For: DATA COMMUNICATION METHOD, ELECTRONIC APPARATUS,

AND PHYSICAL-LAYER-CONTROL INTEGRATED CIRCUIT

PRELIMINARY AMENDMENT

REQUEST FOR APPROVAL OF DRAWING CHANGES

FIG. 6

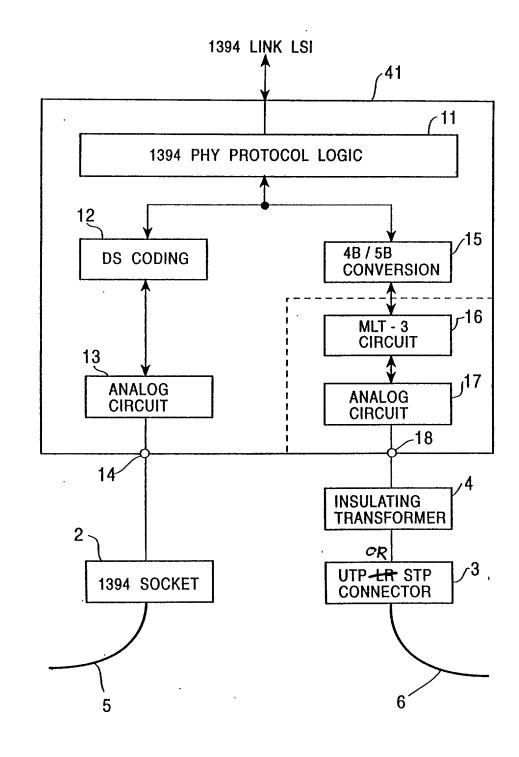
FIG. 6: In block 3, change "LR" to --OR--;

These changes are indicated in red ink on the enclosed photocopies; and are necessary for proper conformance to the written description. The changes are identical to those made in the parent of this application.

FIG. 8: Add the legend "51" to the large block.
